Re: Proposed Private Hospital, Water Street Wahroonga

We refer to the various responses to the Part 3A Application relating to the subject proposal and advise that we have reviewed the matters raised and now confirm as follows in respect of the issues arising that pertain to traffic planning matters. These are considered separately below in response to the matters raised by the RTA, the matters raised by Council, and the matters raised in public submissions.

Construction Truck Access
1 in 400 at A3

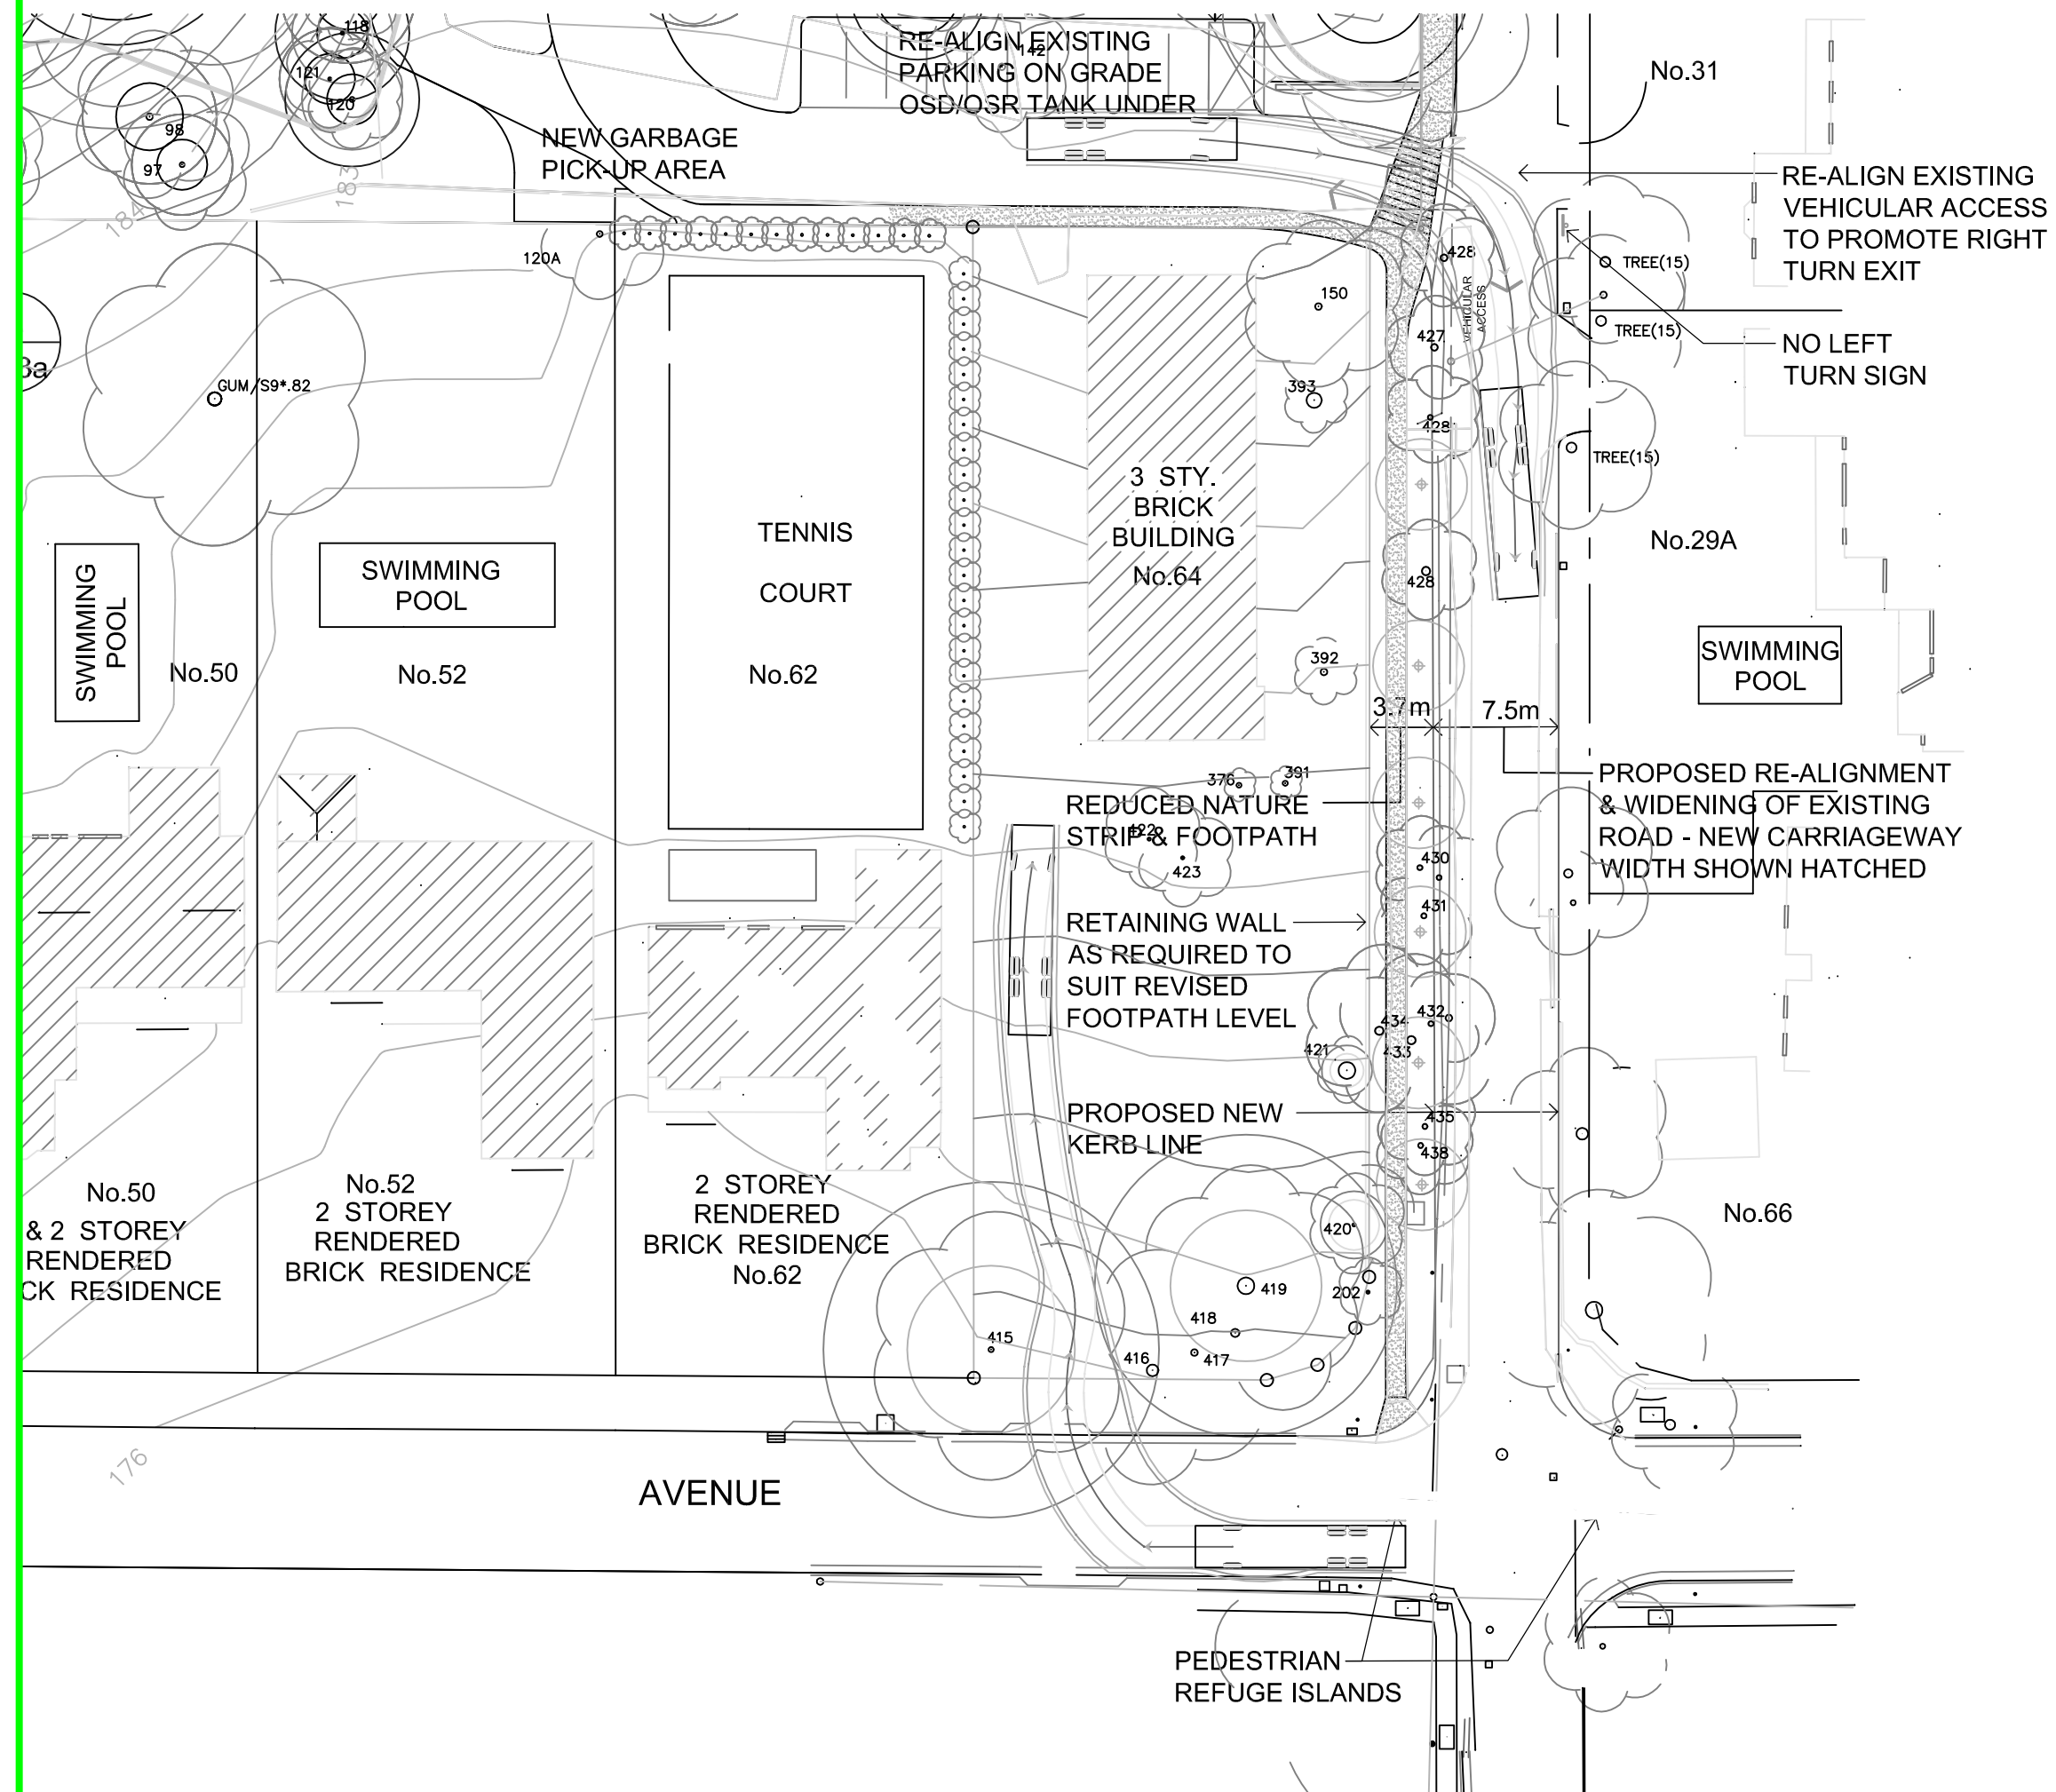
- The need for a detailed demolition and construction plan is acknowledged and has always been proposed in response to a condition of consent, to be prepared and approved prior to the issue of a Construction Certificate. Nevertheless, further consideration has been given to the formulation of access principles for construction and this involves a one-way clockwise flow pattern through the site, with entry via Billyard Avenue and exit via right turns into Young Street to return to Billyard Avenue. This minimises any impacts on Young Street (north of the access) or on Water Street which is a very good outcome. The ability of a 12.5m HRV (rigid) truck to manoeuvre through these accesses is shown in Attachment 1. It is emphasised that this truck represents the worst case and there is no intention to use 19m articulated trucks (semis) during construction. Use will also be made of “truck and dog” combinations which are longer than a 12.5m (rigid) HRV but are more manoeuvrable as they are articulated. The exit via Young Street towards Billyard Avenue will also be facilitated by the proposed widening of Young Street (between the site access and Billyard Avenue) as discussed further below. It is noted that some trucks will still use the Water Street access, which is unavoidable.

- The need to prepare a detailed construction traffic management plan as a condition of consent is accepted as also requested by the RTA. The ability of trucks to turn is a function of the available driveway width and the CTMP will include swept paths that comply with the requirements of AS 2890.2 as well as Austroads Guidelines, based on the principles shown in **Attachment 1**. It is noted that trucks are able to use the full width of the carriageways in all local streets when accessing a driveway as permitted under AS 2890.2 as well as the Australian Road Rules. No use of articulated trucks is anticipated.
